## **Congregation Emanu-El Submission to Victoria City Council for October 6 2022 meeting**

### **Regarding land adjacent to Jewish Cemetery**

## **VICTORIA JEWISH CEMETERY - PROPOSED EXTENSION**

**Tree Inventory**  
**Road Right-of-Way Cedar Hill Road**

*Estimated Radius - Protected Root Zones*  
1:350

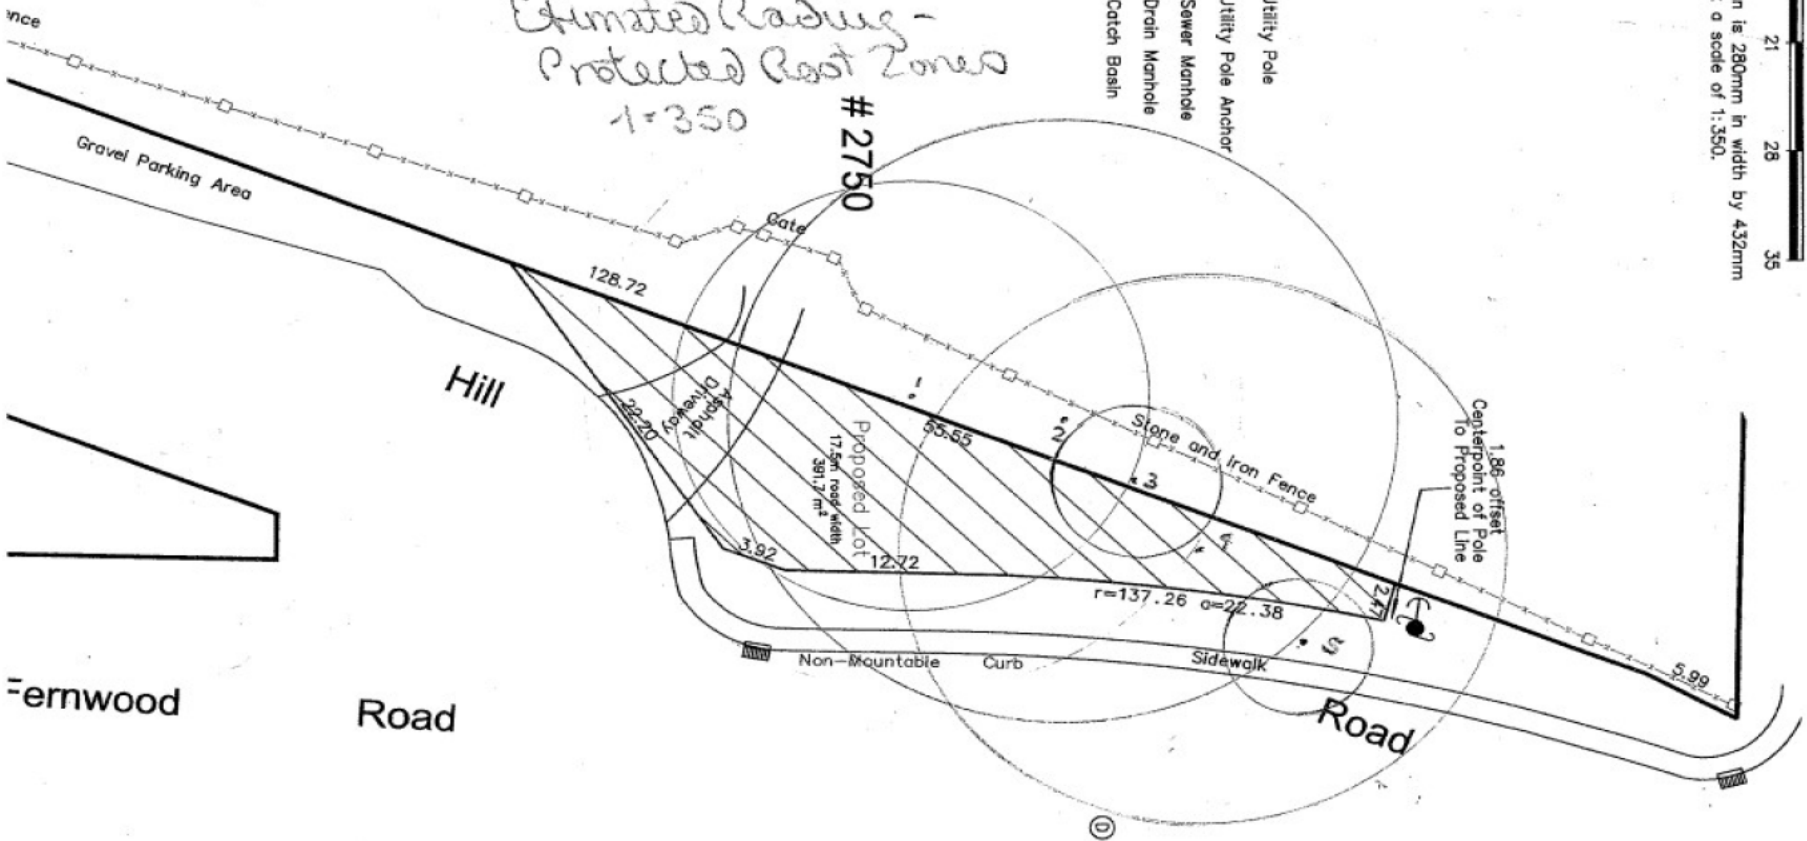
Please find attached a detailed overview of the existing trees at Cedar Hill Rd on the site of interest, and other supporting evidence I used in my analysis, including measurements of diameter at breast height (DBH) in order to determine radius of protected root zone. I have converted all measurements to scale in order to represent these protected radiuses on the 1:350 scale map that was provided with the City of Victoria's Notice of Road Closure documents (excerpt below).

It appears that the 391.1 sq. meters that comprises this entire site proposed for disposal is *completely within protected root zone area* and likewise cannot be disturbed by the activities that may be required for the desired use of this site. Further, behind the existing fence, on the property to which this parcel is proposed to be annexed, while these trees were not measured, it is evident visually that at least ten more protected-species trees of much larger size and likewise

greater DBH whose root zones obviously extend within the proposed site will also be affected by any disruption of soil in the existing right-of-way space.

To determine the radius of protected root zone, the diameter at Breast Height (DBH) of all trees in the existing road right-of-way were measured according to the method defined in the Tree Protection bylaw or  $DBH \times 18$

Ref	Species	Distance from existing fence			Circumference at BH 1.4 m				DBH ( $D = C/\pi$ )			Protected Species	Protected Diameter (>30cm)	Protected Root Zone ( $DBH \times 18$ )		
		(ft)	(m)	1:350 scale (cm)	Trunk 1 (ft)	Trunk 2 (ft)	Trunk 3 (ft)	Total (ft)	(ft)	(m)	(cm)			(ft)	(m)	1:350 scale (cm)
1	Quercus Garryana (Garry Oak)	11.6	3.5	1.0	7.2	0.0	0.0	7.2	2.3	0.7	69.3	yes	yes	41.0	12.5	3.6
2	Quercus Garryana (Garry Oak)	3.0	0.9	0.3	2.0	5.3	2.5	9.8	3.1	1.0	95.3	yes	yes	56.4	17.1	4.9
3	Quercus garryana (Garry Oak)	9.0	2.7	0.8	2.6	0.0	0.0	2.6	0.8	0.3	25.2	yes	no	14.9	4.5	1.3
4	Quercus garryana (Garry Oak)	13.0	4.0	1.1	4.3	4.8	0.0	9.1	2.9	0.9	88.1	yes	yes	52.2	15.9	4.5
5	Quercus rubra (Northern Red Oak)	22.4	6.8	1.9	2.2	0.0	0.0	2.2	0.7	0.2	20.9	no	no	12.4	3.8	1.1
6	Nut tree?	49.6	15.1	4.3	3.2	0	0	3.2	1.0	0.3	31.0	no	yes	18.3	5.6	1.6
